# RotorSport UK Ltd Service Bulletin (Permit)

<b>Title: Calidus water hose clamps</b>		
<b>SB-117 Iss1</b>	<b>Related documents</b> Modification: none CCAR No.: None	<b>Compliance Category:</b> <del>OPTIONAL</del> or <b>RECOMMENDED or MANDATORY</b>
<b>Applicability</b>		
<b>Aircraft type &amp; model:</b>  <b>Calidus</b>	<b>Aircraft serial Nos. affected:</b>  <b>See text</b>	
The maintenance manual to be referenced is this stated or subsequent issue.		RSUK0061 Iss: 8
<p>This form is the response from RotorSport UK Ltd either against a problem found in the product in service requiring a containment or rectification action, or as service information for aircraft modification incorporation. For help, contact RotorSport on 44(0)1588 505060, or email <a href="mailto:compliance@rotorsport.org">compliance@rotorsport.org</a>.</p> <p>The technical content of this document is approved under the authority of the UK CAA Design Organisation Approval Ref. <b>DAI/9917/06</b></p>

**AG-SB-2016-07-B-EN – Clamp water hose kit**

Fig. 1 clamp at end of water hose

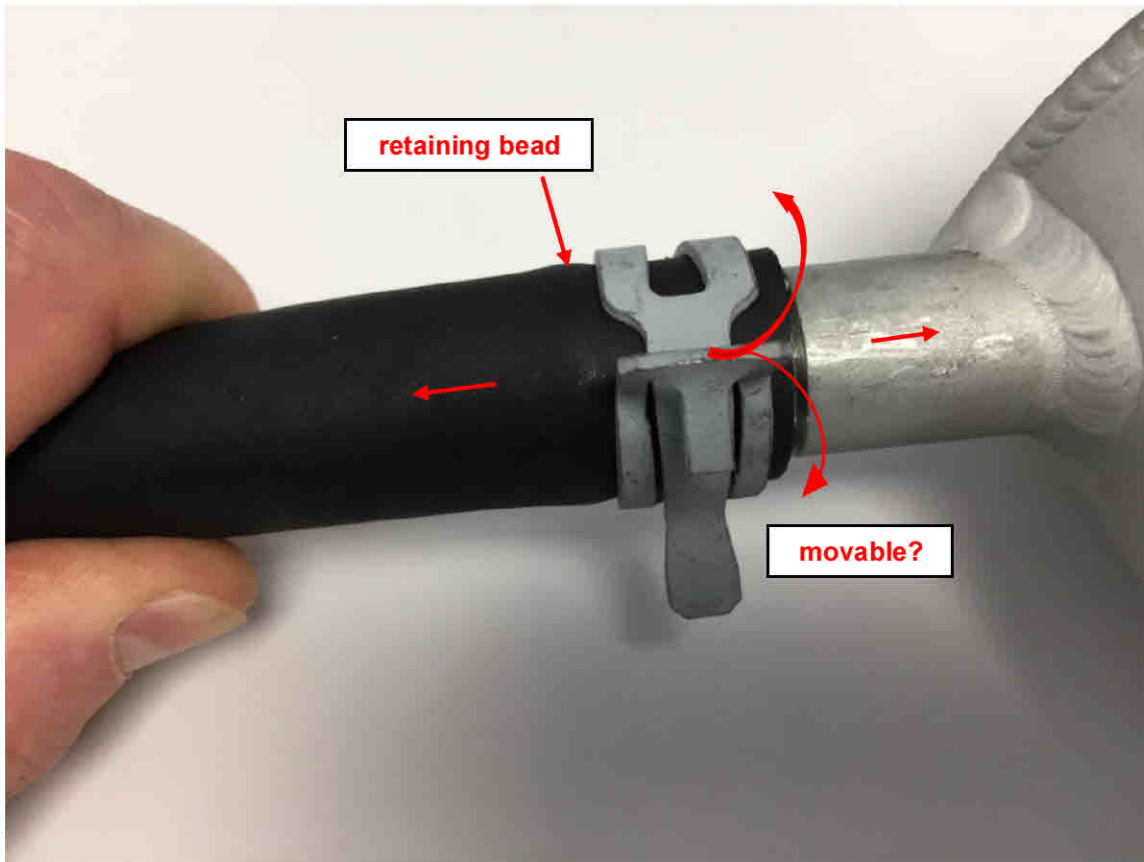
- 1 Inspection; Check that the two clamps at either end of the water hose connecting the pressure tank to the coolant system are fitted adjacent to, and not over, the retaining bead of the tank pipe, and can't be moved.
- 2 Rectification; If the clamp is incorrectly positioned, reposition and recheck the hose cannot be moved. If the hose and clamp are not secure, drain some coolant to allow the hose to be disconnected. Remove the hose, replace the two hose clamps with 24mm clamps and refit. Work in accordance with, and replenish the coolant in accordance with, the Aircraft Maintenance Manual.

Fig. 3 clamp at pressure tank end of water hose

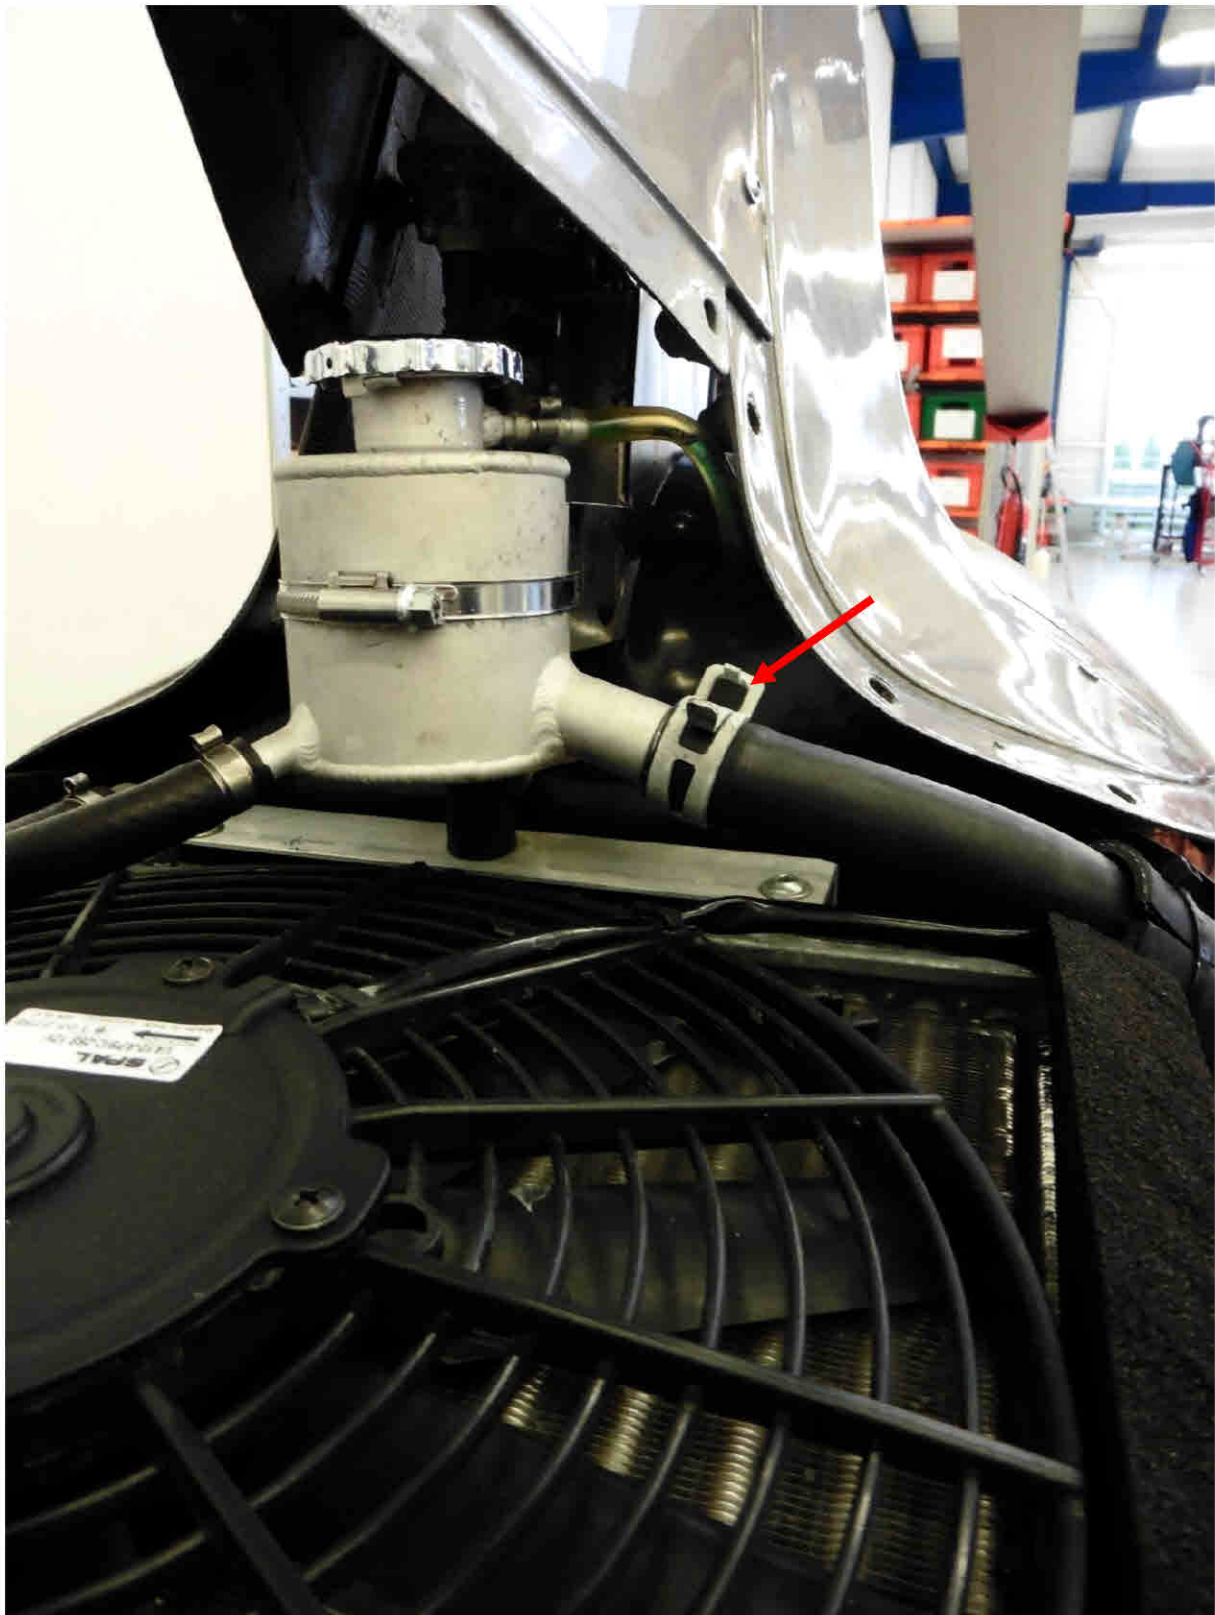
Whilst it is not believed that there are other cases in service, this service bulletin recommends that the security of this connection is checked. If considered questionable, then the 26mm clamp fitted is replaced with a 24mm clamp.
